Department of Transportation
and Public Facilities
Southeast Region

JNU AMHS - AUKE BAY
FAST VEHICLE FERRY
SUPPORT FACILITY
SHAK-9500(103) ~ 67763

As-built Plans

1 FOUNDATION PLAN

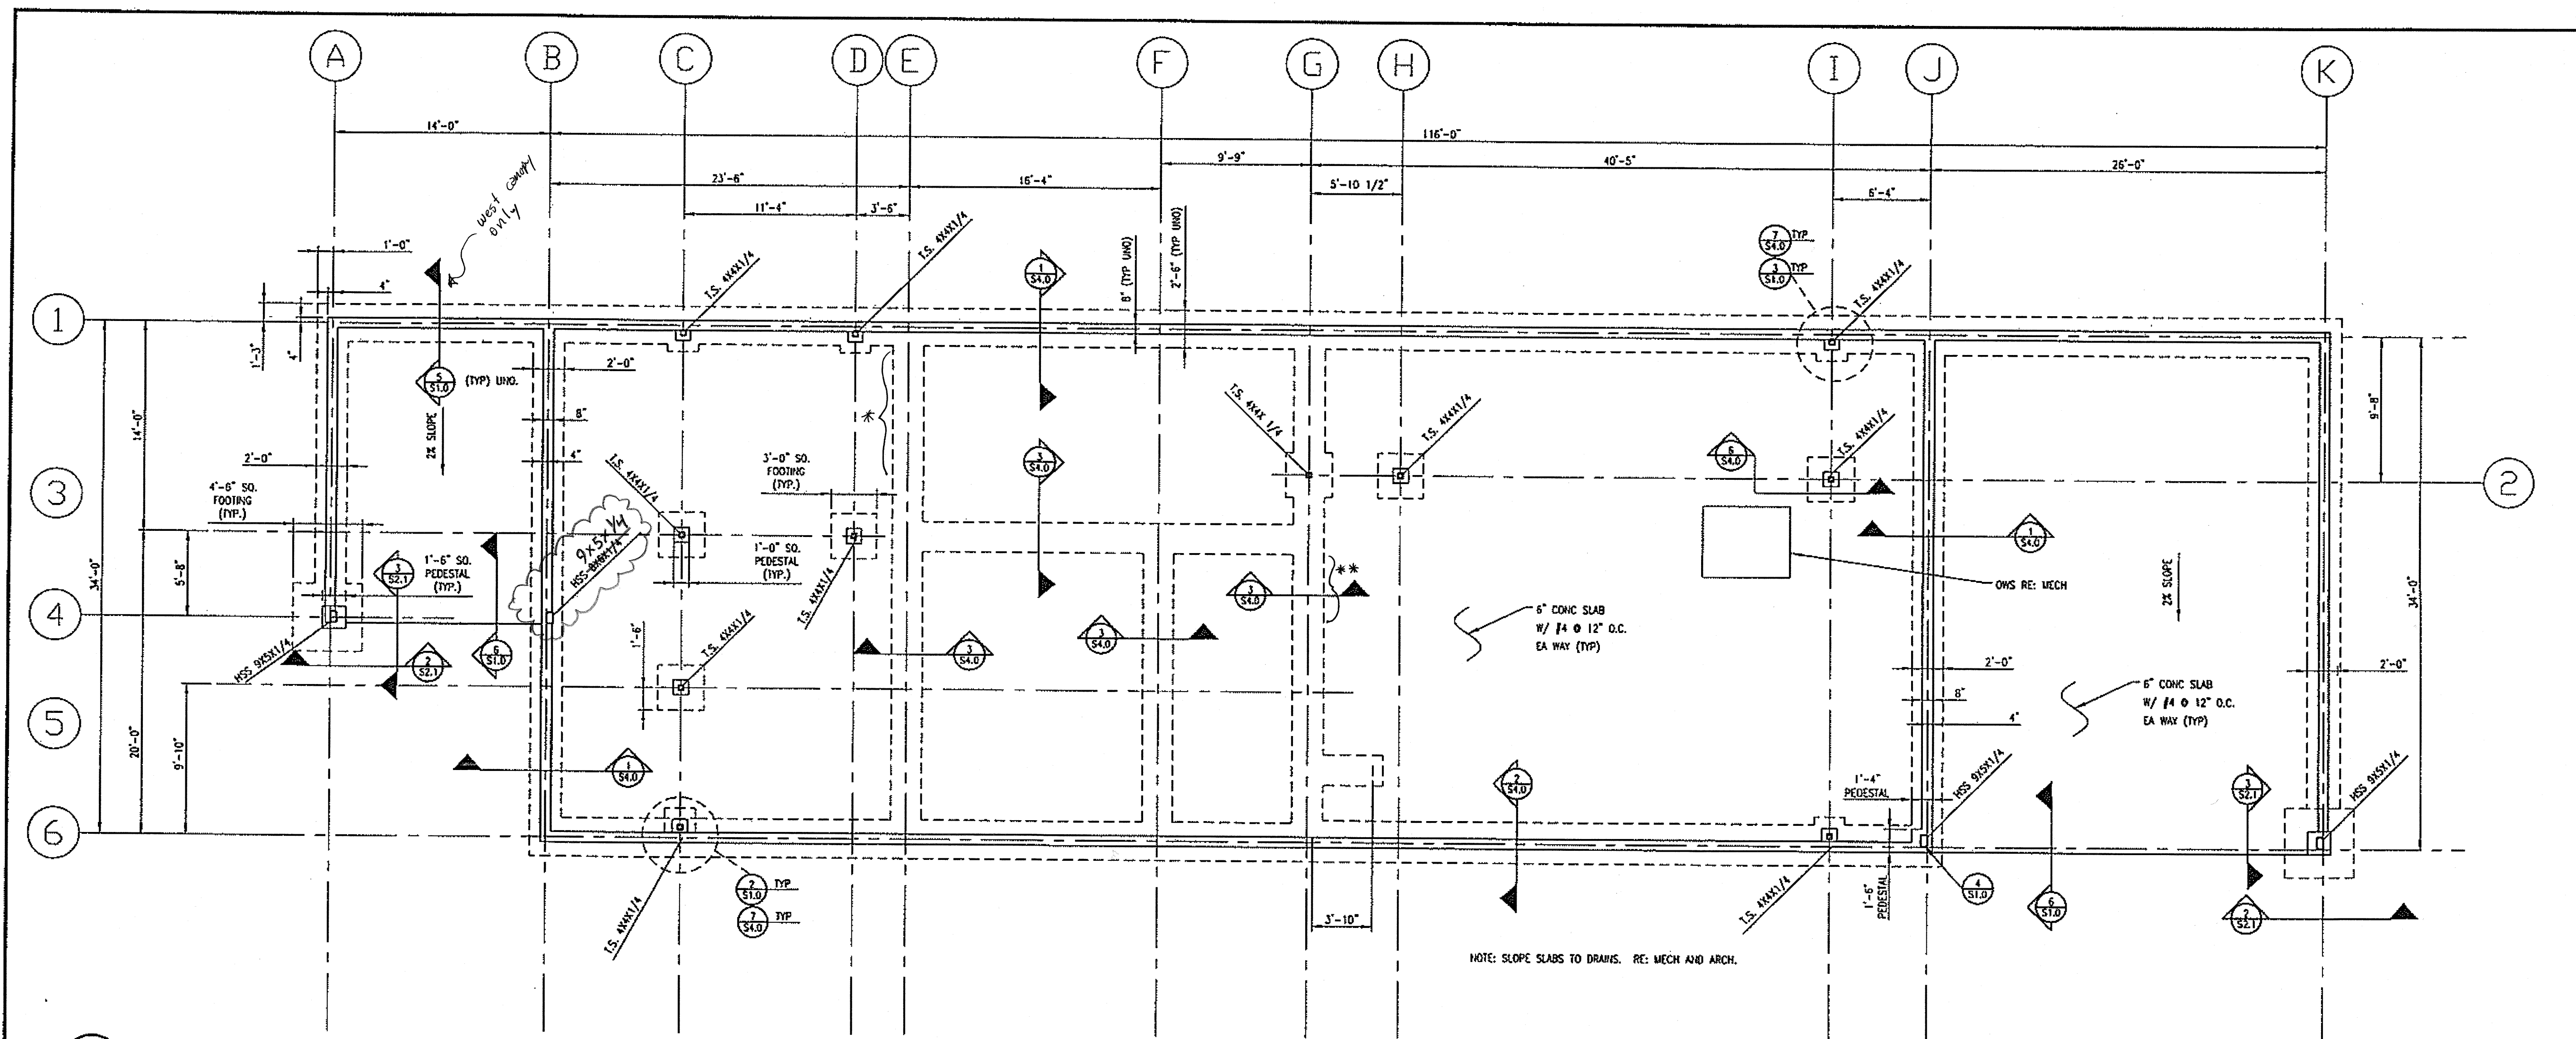
Note: At grid coordinate B:4 column design changed per Design Alaska 6/24/08 response to DCVR #10. This change included in Change Order No. 1.

* #4 stirrups not installed in thickened portion of concrete slab due to conflict with recess for cooler/freezer

** #4 stirrups not installed this location due to conflict with vent plumbing and trap primers. LVL header above vent manifold in wall

1 ROOF FRAMING PLAN
 S3.0 NTS 1:64

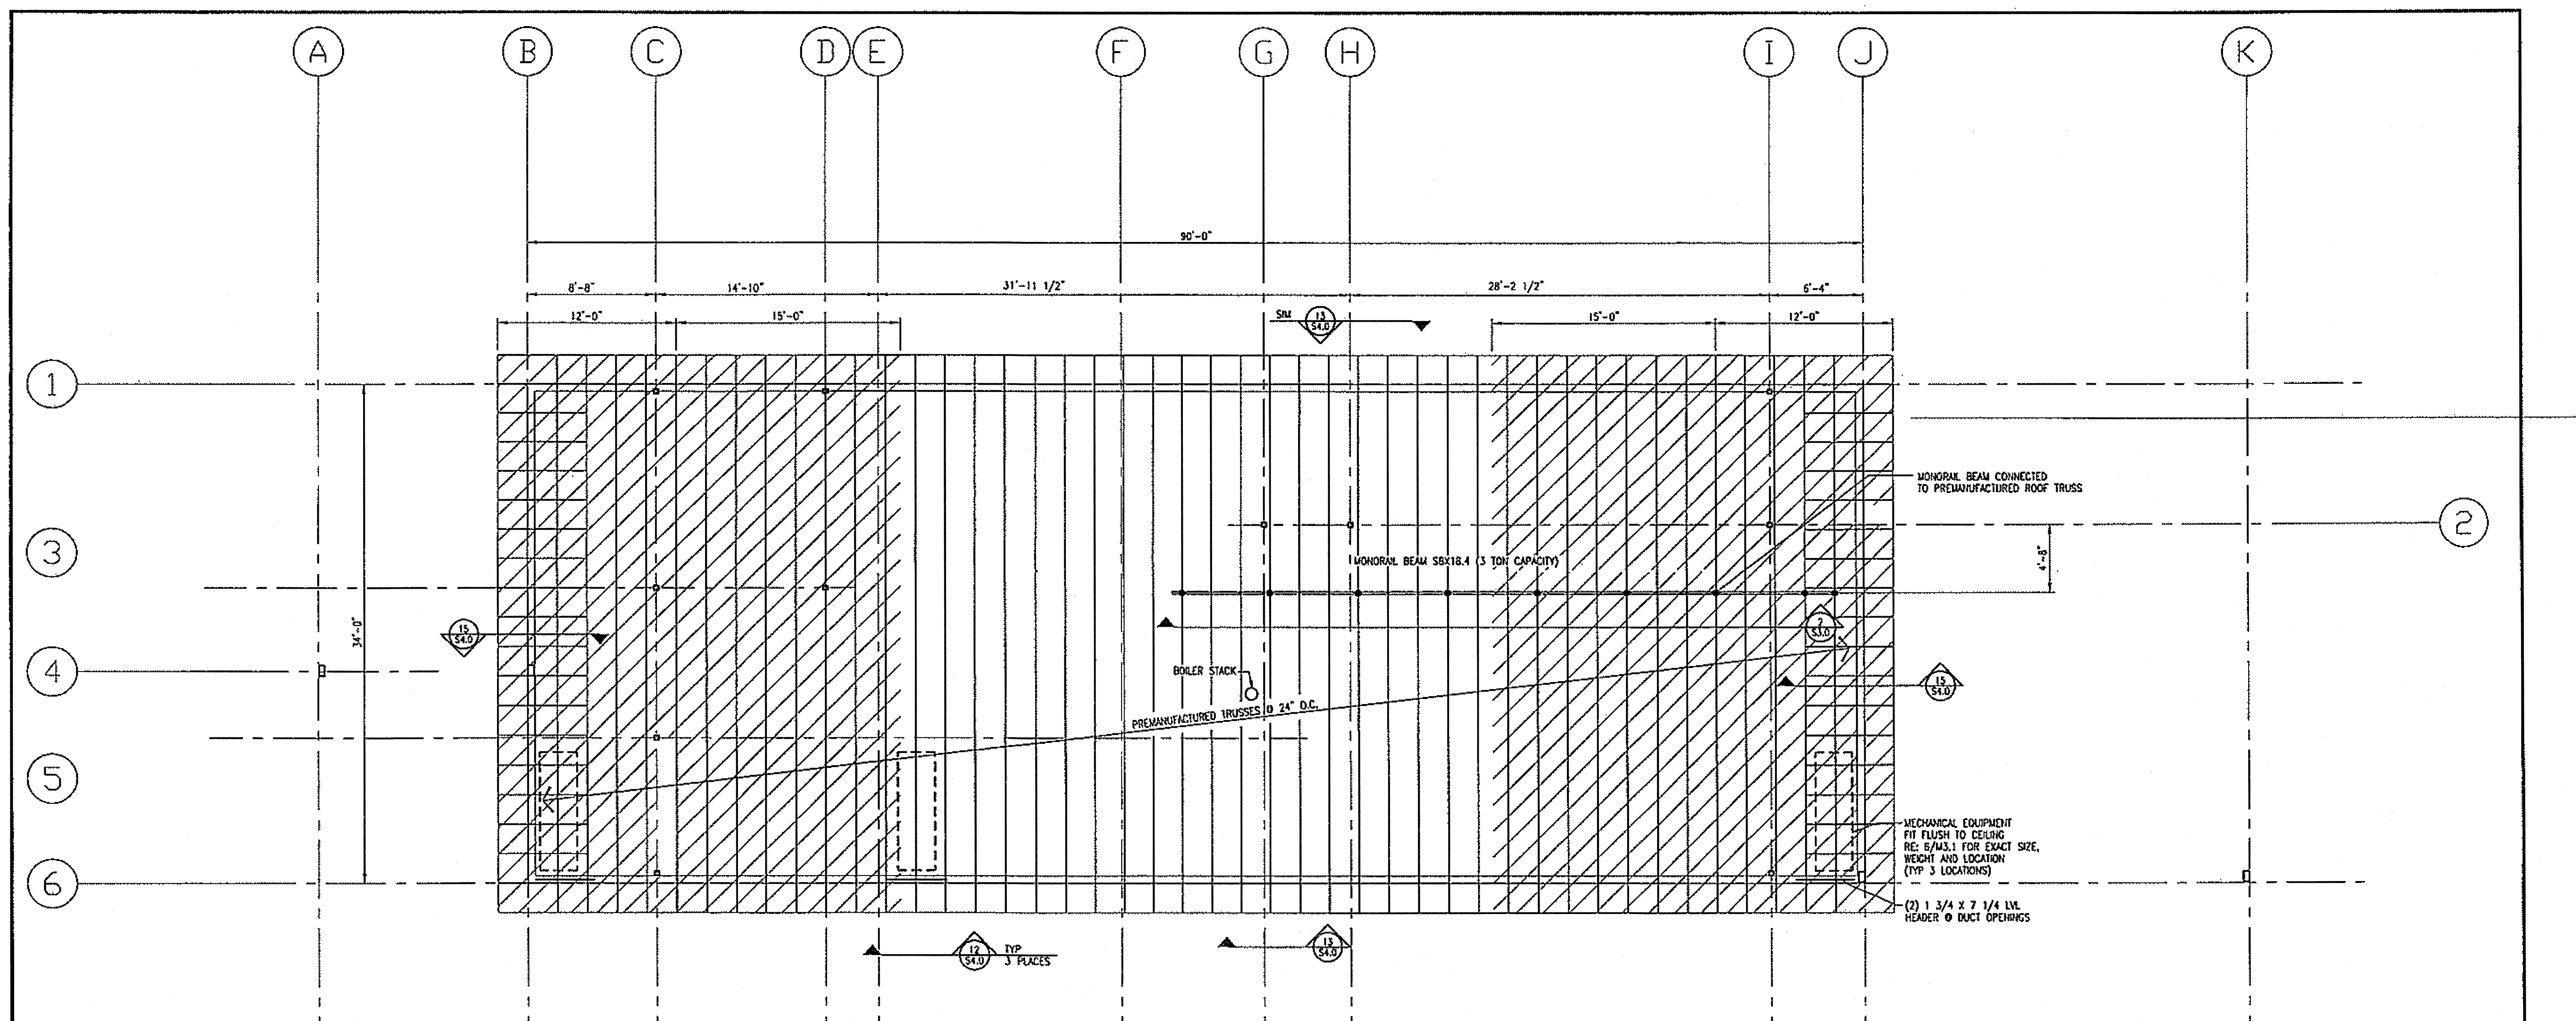
See Design Alaska 5/15/08 response
 to DCVR-A-006. Canopy Column Details 2152.1 + 3/52.1
 were replaced. A detail for column base plates is provided.
